Notice of Allowability	Application No.	Applicant(s)	
	09/944,233	MODEN ET AL.	
	Examiner Brenda A Lamb	Art Unit 1734

EXAMINER'S AMENDMENT

Fig. 18

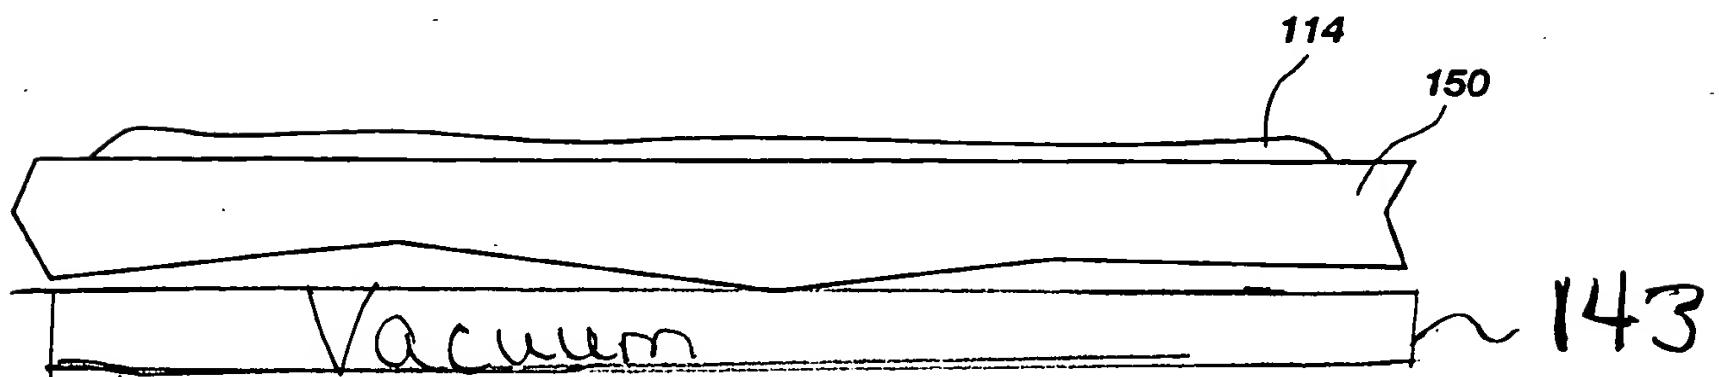
The following changes to the drawings have been approved by the examiner and agreed upon by applicant: The attached drawing change with respect to Figure 18 depicting the claimed vacuum 143 arranged below coating stencil 150. In order to avoid abandonment of the application, applicant must make these above agreed upon drawing changes.
